7714 YONGE STREET, THORNHILL HERITAGE CONSERVATION DISTRICT

RENOVATION OF EXISTING HERITAGE HOUSE, AND REAR
ADDITION AT 7714 YONGE STREET, THORNHILL HERITAGE
CONSERVATION DISTRICT

To the Members of Heritage Vaughan

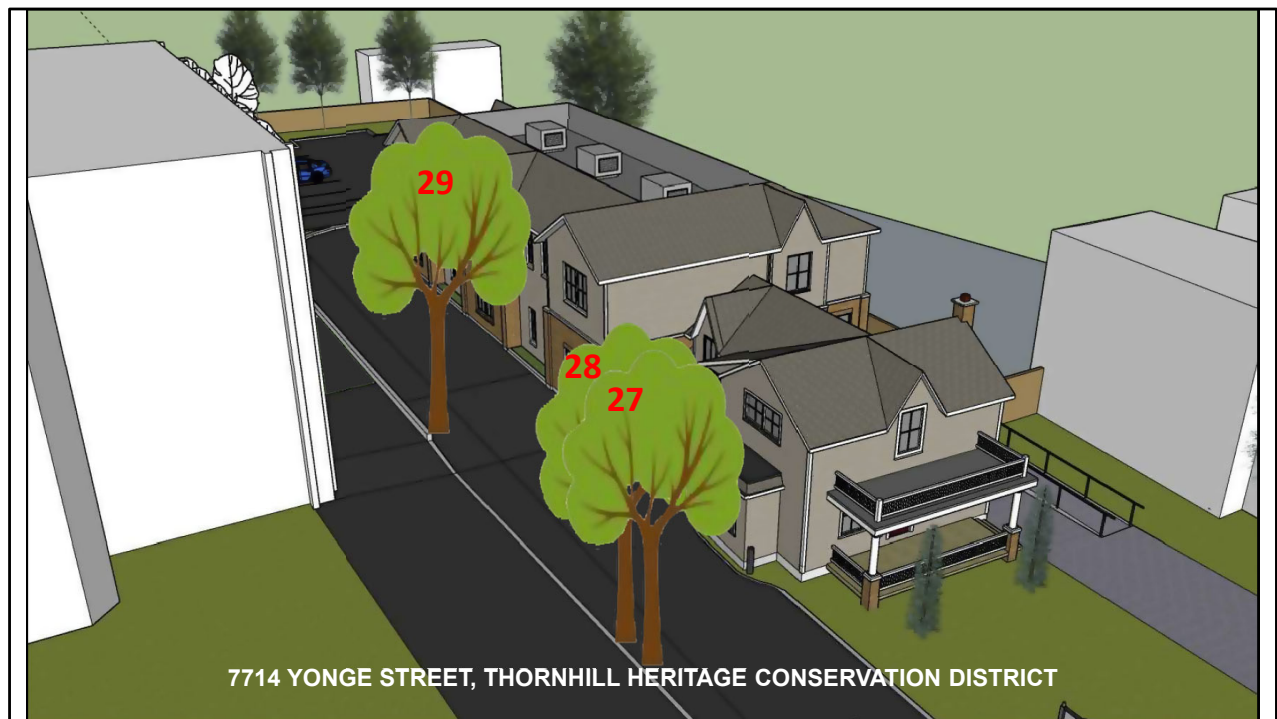
In particular, the 3 mature trees in good condition shown here are to be preserved but are not show on the 3D models.

In overlaying the 3D model, you can see the trees are not shown and the driveway area is fully paved.

If we add in the trees that are labelled as being preserved in the arborist report, trees 27, 28, and 29, we can see that they would not have permeable ground around them which would make it unlikely that they would survive.

Instead, I would like to propose that the existing driveway be shared between Bell Canada and 7714 Yonge St.

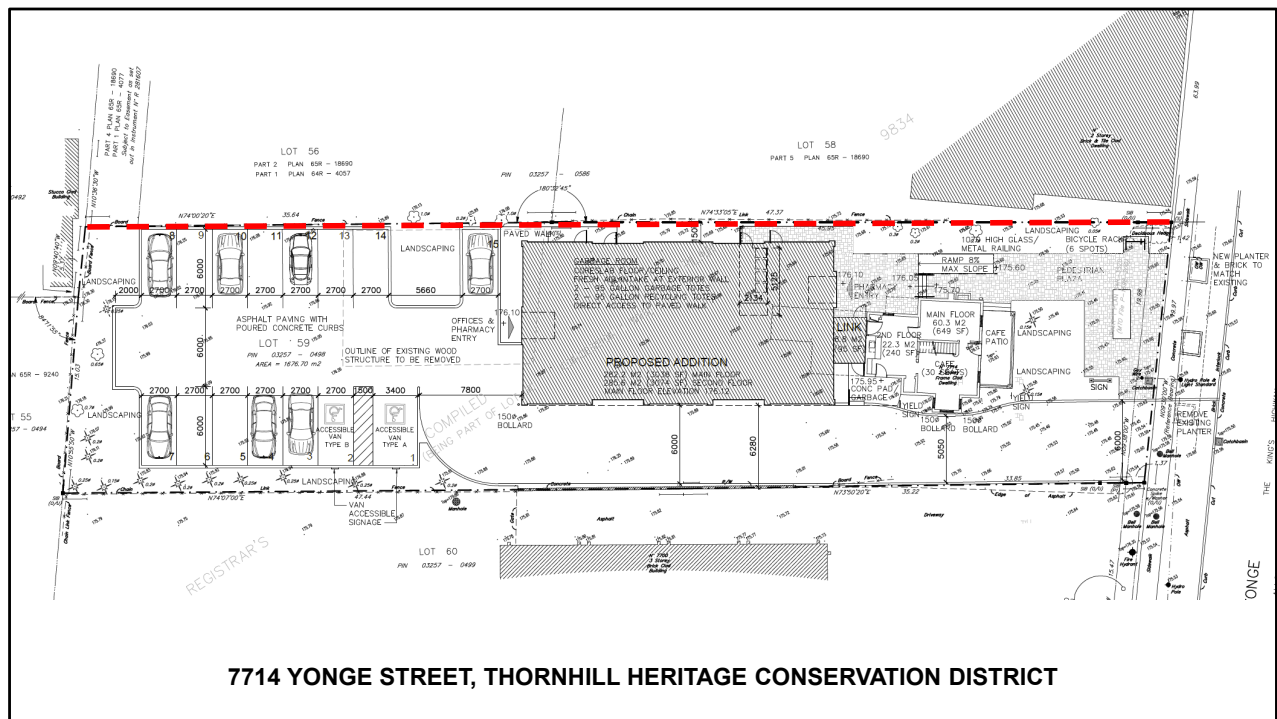
Going back to the high-angle view, please note the error marked with a red X to the right. It shows a fence attached to my building.

This cannot be allowed as it would heavily encroach on to my property and I already have a path there, not to mention the large historic trees.

As the property line extends linearly from the corner of their proposed parking lot, many part of this drawing encroach and I will not allow on my property.

I think we can all agree that the property line is a completely straight line and that the 3D visualization is incorrect.

This mean that this image should be corrected or marked as being incorrect.

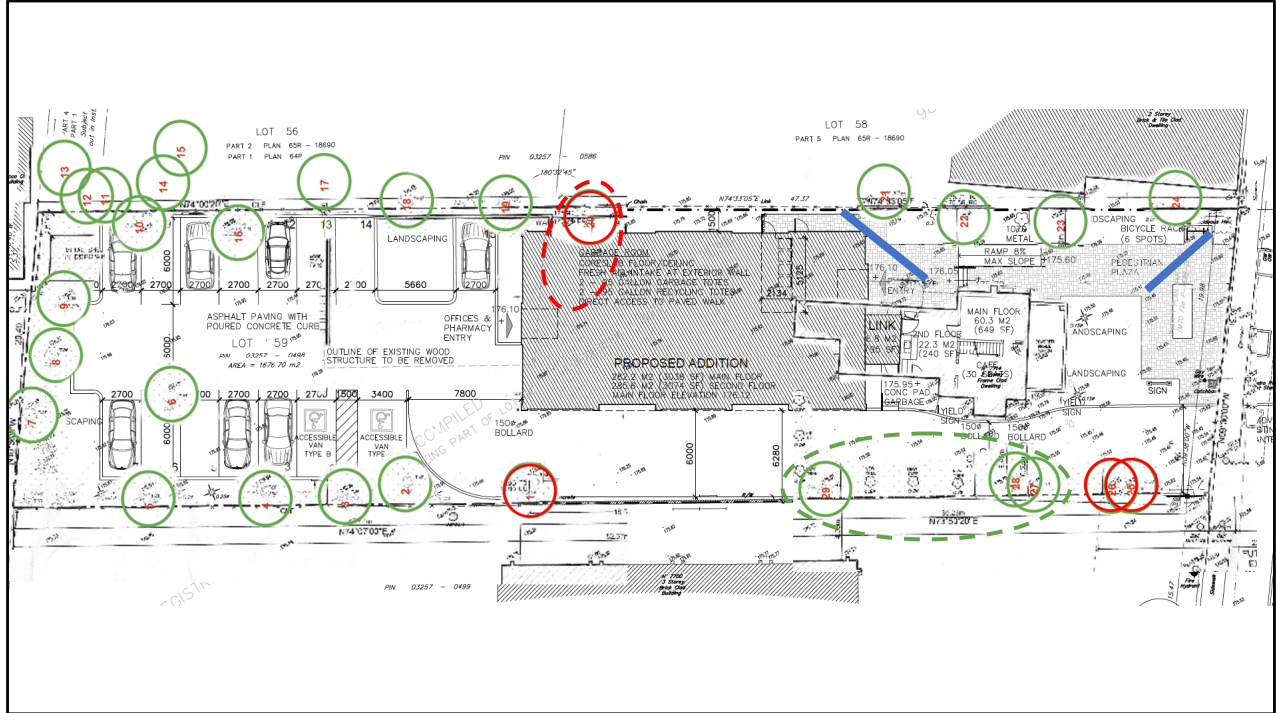
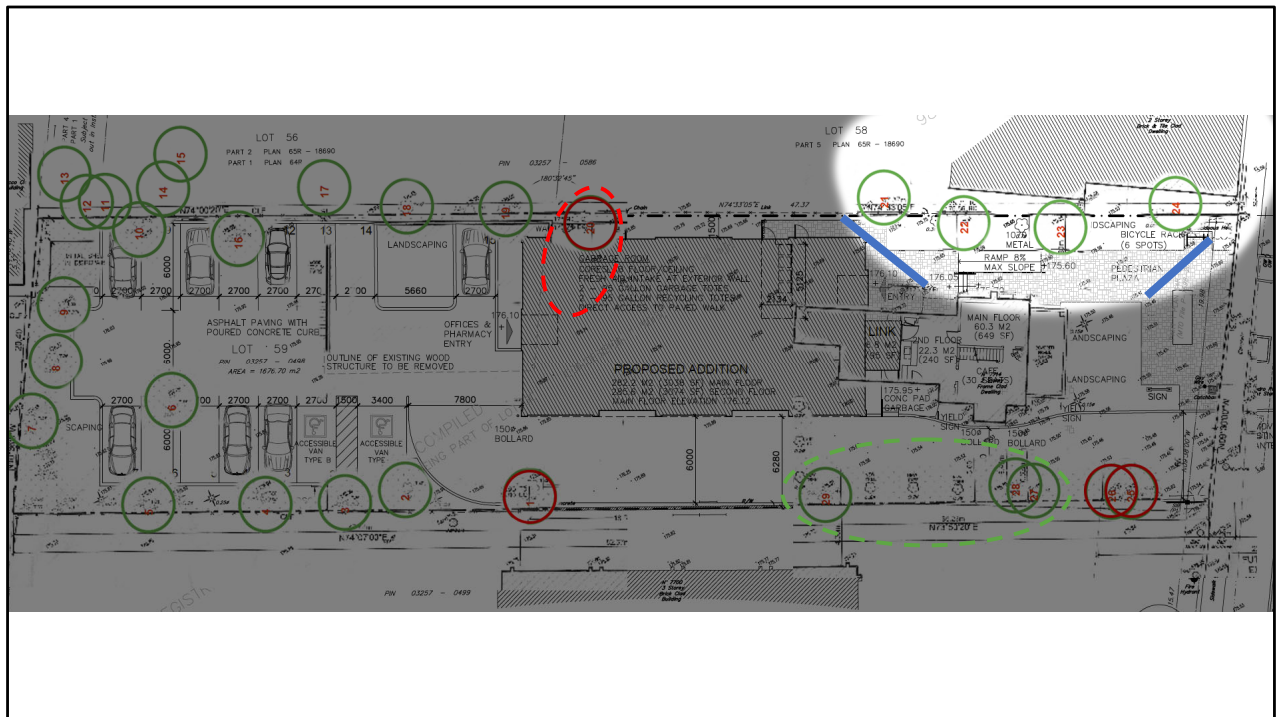
Finally, the demolition and construction phase is concerning. While I’m happy to see “hand demolish” for some parts, the allowance of hydraulic equipment requiring vibration monitoring with danger to the foundation, is concerning especially as my building is so close.

As stated here, the vibration monitoring is unacceptable as it only notifies designated recipients after it is too late.

Please see the blue bars to the north east side of the property that represent concrete barriers preventing heavy equipment and large vehicles to access the property there to prevent damage to our shared trees and collisions with the my building or the Stark house.

As both the Stark house and my building. Francis Block, are very old, we need a strategy of prevention, not monitoring and later repair or destruction. Therefore, I request that the concrete barrier proposed on Page 266, be extended to both sides of the existing driveway.

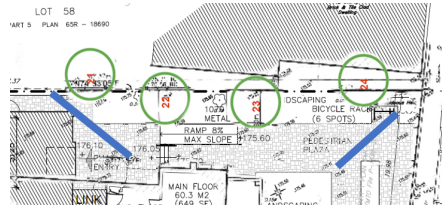
This is because, as you can see, any construction vehicle coming to the site will believe this is the access pathway to the new construction at the rear of the property. This will certainly damage the trees and vibrations could damage both our foundations.

By placing concrete barriers at both ends of the current driveway, the accidents can be prevented entirely.
